National Transportation Safety Board

Safety Recommendation

Date: 6 February, 2001

In reply refer to: A-01-03 through -05

Figure 1. Static port heater installation.

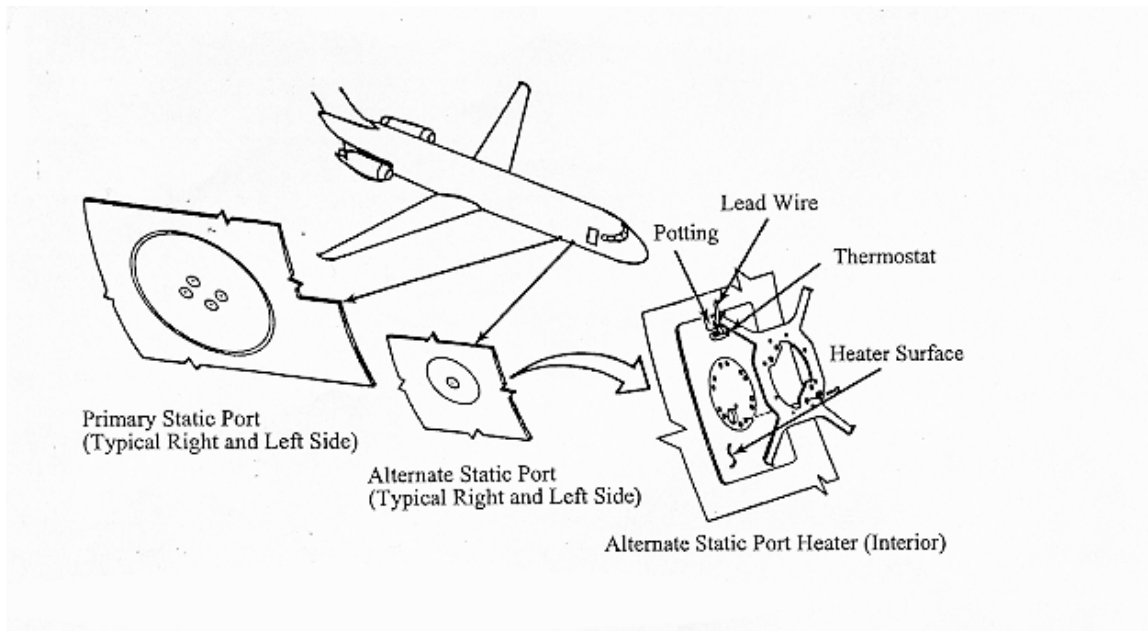
McDonnell Douglas MD-88 airplanes are equipped with two static port heaters (one primary and one alternate) on the left interior sidewall and two on the right interior sidewall (see figure 1). The heaters are flush-mounted against the static air pressure sensing ports to ensure that the ports do not become blocked by ice.² The heaters are manufactured by Electrofilm Manufacturing Company, Valencia, California, and are powered by 115-volt alternating current through a 10-ampere circuit. The heaters are controlled by a switch in the cockpit and are normally on from before takeoff until after landing. The heaters have two resistive elements. One of the elements is always powered, whereas the other element receives power, as necessary, depending on the temperature of the heater. A thermostat on the heater controls whether power is applied to the second heater element; the thermostat applies power when the temperature is less than 80° Fahrenheit (F) and removes power when the temperature is 180° F. The maximum power used by the alternate static port heater is 225 watts.

The National Transportation Safety Board's investigation of the Covington, Kentucky, incident revealed that a spark from the right alternate static port heater ignited the fire and that the fire propagated by consuming the metalized Mylar covering on the sidewall insulation blankets surrounding the heater. There was substantial damage to the insulation blankets and soot and heat distress to components in the area, such as some floor structure and a potable water tank. Postincident examination of the right alternate static port heater revealed localized soot on the thermostat case, on the lead wire that carries the 115 volts to the thermostat, and on the red potting compound in the area where the lead wire is bent sharply around the thermostat case. The conductor of the lead wire was exposed at the point where the wire was bent around the thermostat case. Investigators concluded that the spark that ignited the metalized Mylar covering resulted from electrical arcing between the exposed conductor of the lead wire and the grounded thermostat case.

electrical connector; two had charred and exposed heater elements on the heater surface; and seven had cracked and flaked rubber on the heater surface, which can lead to electrical arcing if a liquid is introduced.⁵ The report concluded that the sharp bends in the heater elements can concentrate the heat and cause disbonding, which can expose the heater elements.

Concurrent with its inspections of the static port heaters in its MD-88 and MD-90 fleet, Delta Air Lines removed the metalized Mylar-covered insulation blankets from around all of these heaters and stated that it plans to install metalized Tedlar-covered insulation blankets in those areas in the future. Further, after its examination of the damaged heaters, Delta Air Lines' Engineering Department recommended that all static port heaters in its MD-88 and MD-90 fleet be replaced and that the part be life limited to 6 years. Delta Air Lines' Engineering Department further recommended that the heater be redesigned to provide a more generous bend radius to the thermostat lead wires and heater elements.

Issue an airworthiness directive requiring operators of MD-80, MD-90, and DC-9 series airplanes to inspect the primary and alternate static port heaters on these airplanes for evidence of electrical arcing or thermal damage and, if such damage is found, replace the heaters. (A-01-03)

Initiate a design review of the primary and alternate static port heaters on MD-80, MD-90, and DC-9 series airplanes and, if feasible, require design changes to reduce the potential for arcing. (A-01-04)

Issue an airworthiness directive requiring the replacement of metalized Mylar-covered insulation blankets near primary and alternate static port heaters on all MD-80 and MD-90 airplanes with approved metalized Tedlar-covered insulation blankets at the earliest maintenance opportunity, in accordance with Alert Service Bulletins MD80-30A092 and MD90-30A023. (A-01-05)
